Main oven flame outage

DESCRIPTION:

Old type of rear panel

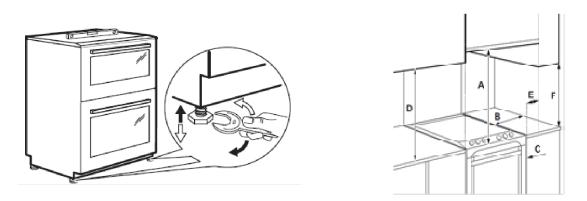
As a next step is required to exchange the rear panel according to table at the end of this document.

Old rear panel	New rear panel	Description
3877357065	140041963046	To improve ventilation
3877357040	140041963038	To improve ventilation
3877357032	140041963020	To improve ventilation
3877357016	140041963012	To improve ventilation
